PUBLIC INTEREST REVIEW FOR GROUND WATER APPLICATIONS

SUBJECT: Application G- 17551 Supersedes review of _____
Date of Review(s)

A. GENERAL INFORMATION: Applicant's Name: Virtue Financial Solutions, LLC County: Baker

Application G-17551, Virtue Financial Solutions, LLC

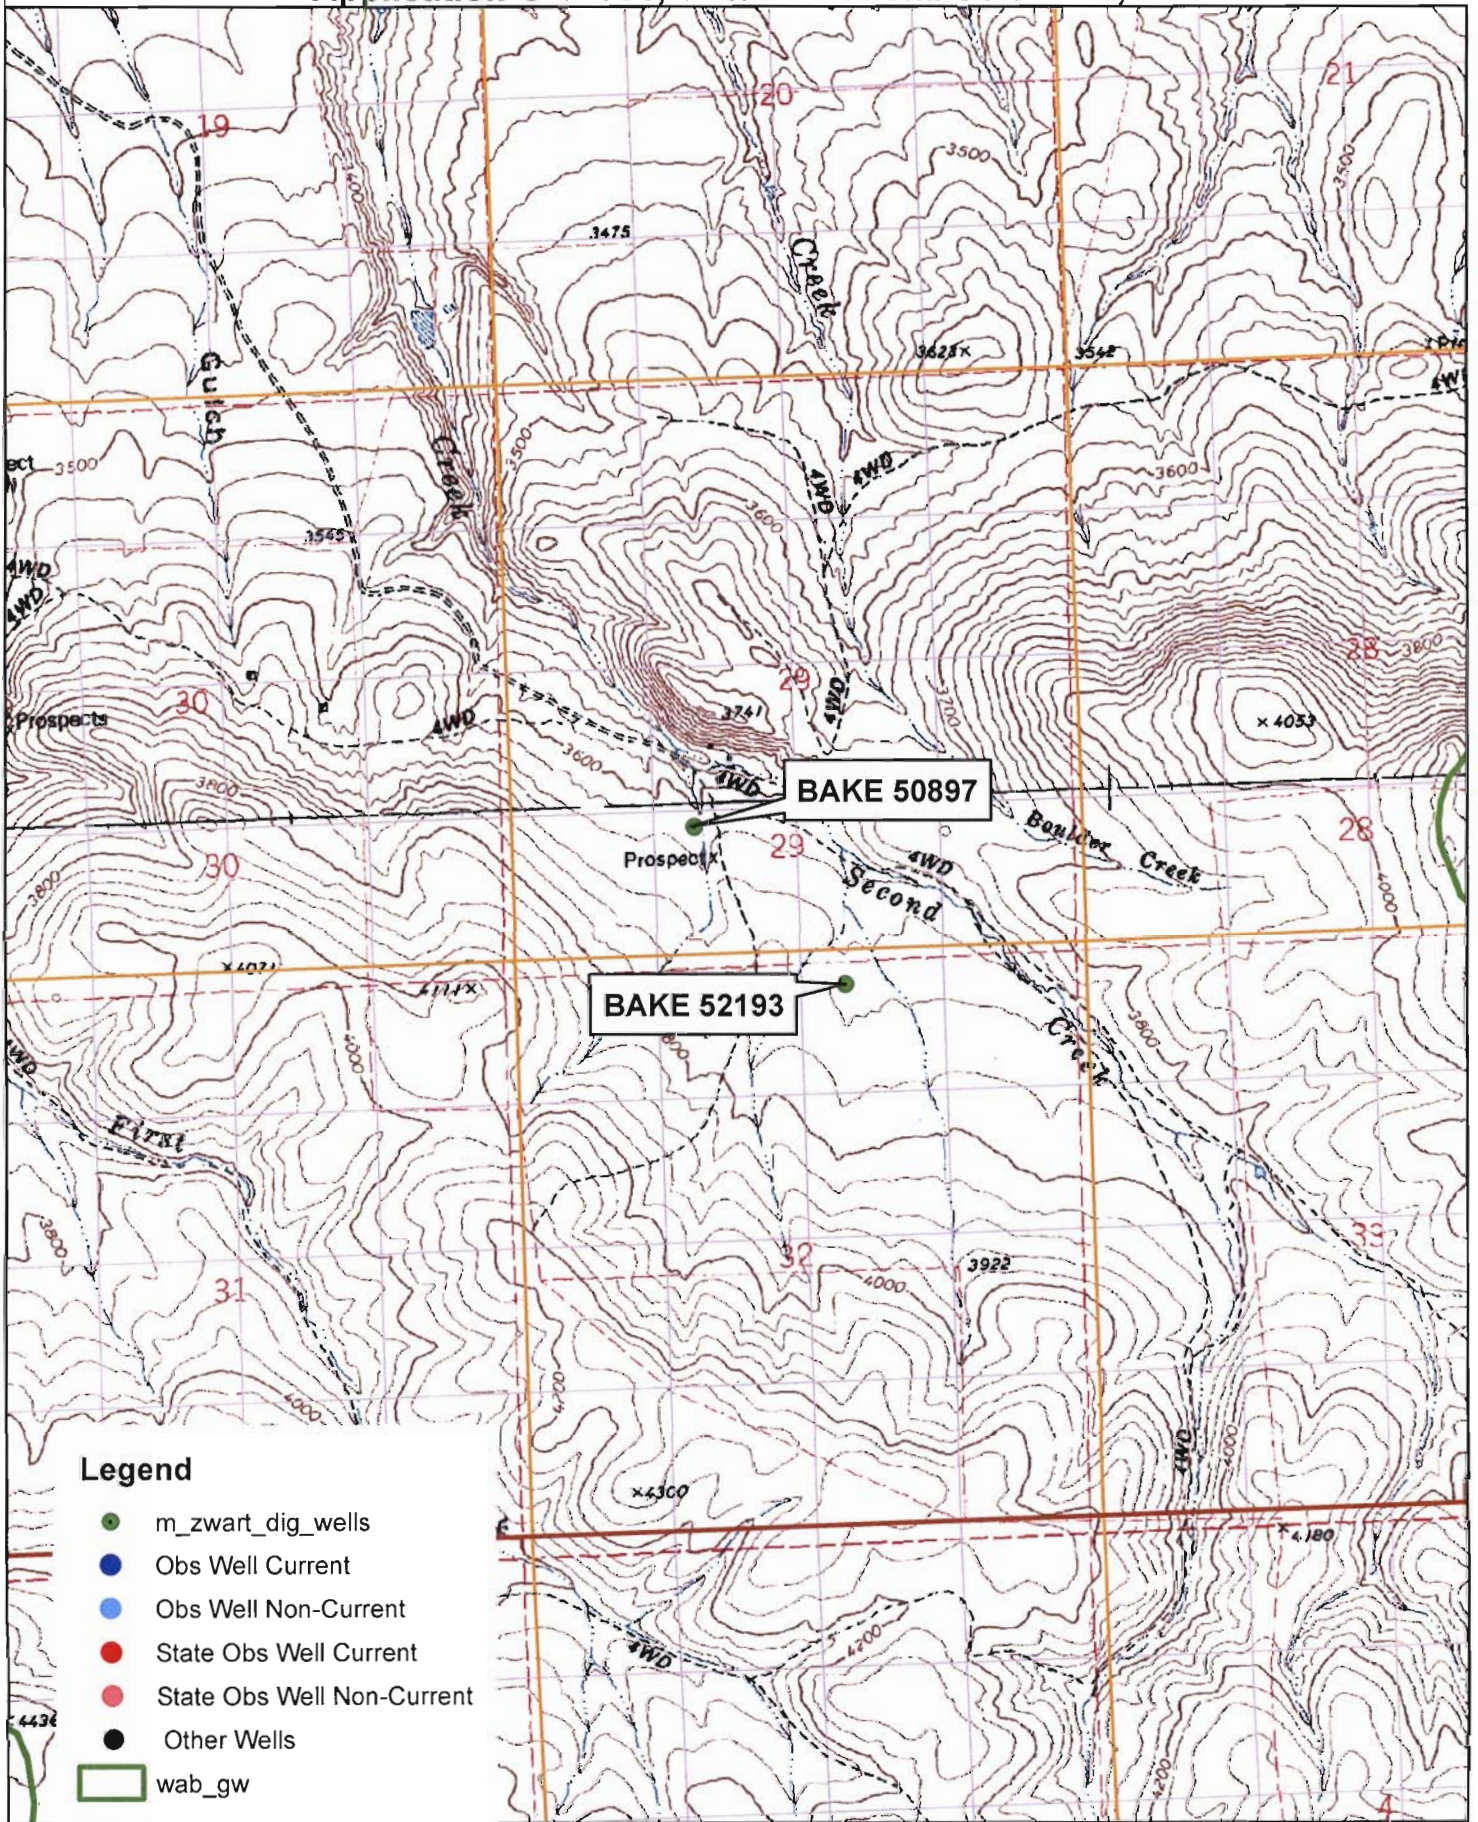
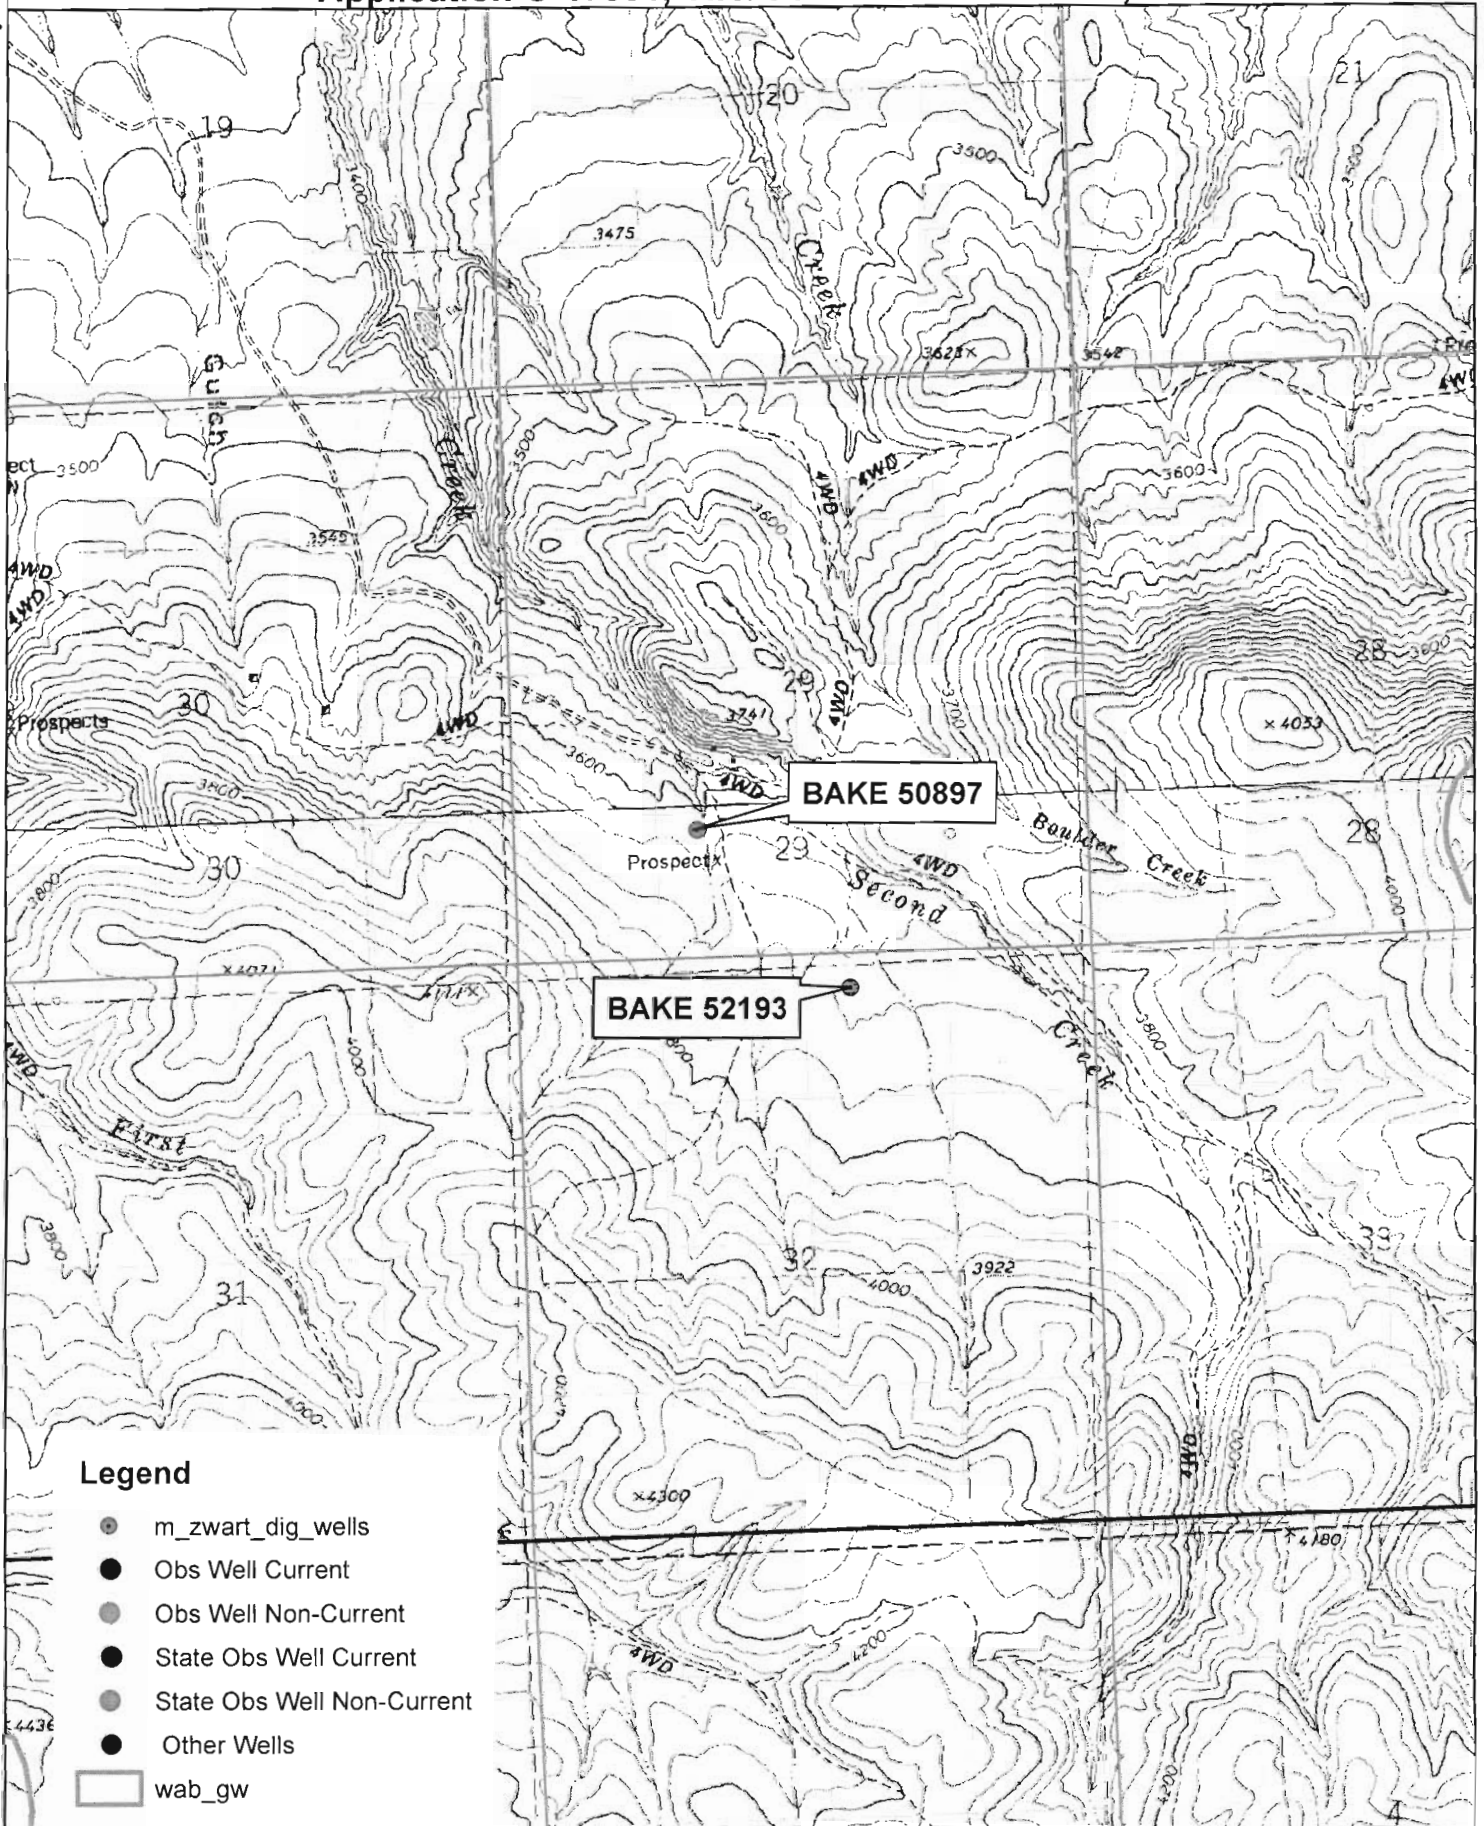
A4. Comments: The provided metes and bounds above do not agree with the GPS locations also provided. The well locations I plotted on my map were interpolated from these locations and aerial photography coverage.
